SERVICE LETTER

No. 525

Piper Aircraft Corporation

Subject: Addition of Lock Washers to Electrical Switch Installations

Typical Switch Installation

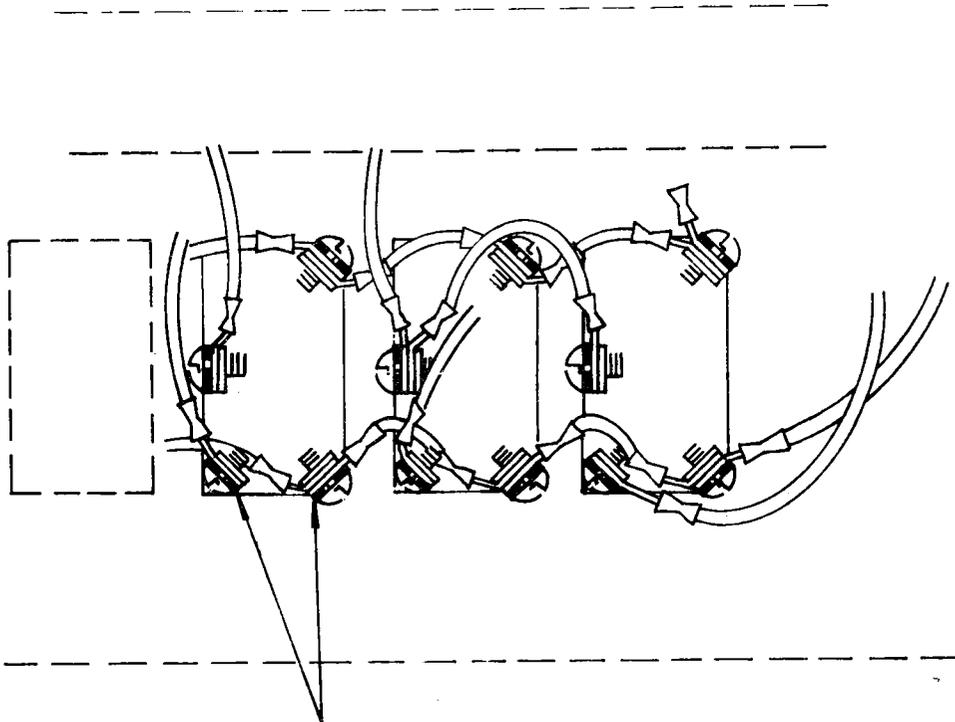
Lock Washer (AN936-A6) must be installed under screw head on each switch terminal.

Instructions: Visually inspect the following switch installations to determine if lock washers (AN936-A6, Piper part number 407 133), have been installed under the head of each terminal screw.

.....
Typical Circuit Breaker and Circuit Breaker Bus Bar Installation

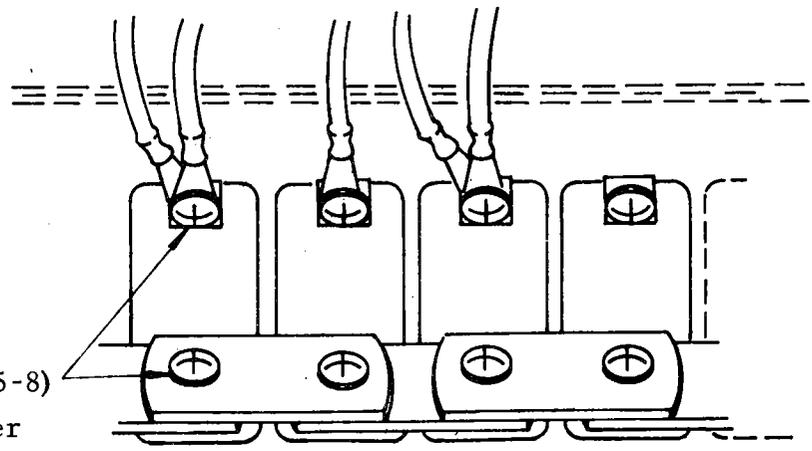
Lock Washer - (AN935-8) must be installed under screw head at each circuit breaker terminal.

It will also be necessary to inspect the circuit breakers and circuit breaker bus bars pertaining to the above switch installations to determine that lock washers (AN935-8, Piper part number 407 103) have been installed under the head of each terminal screw.
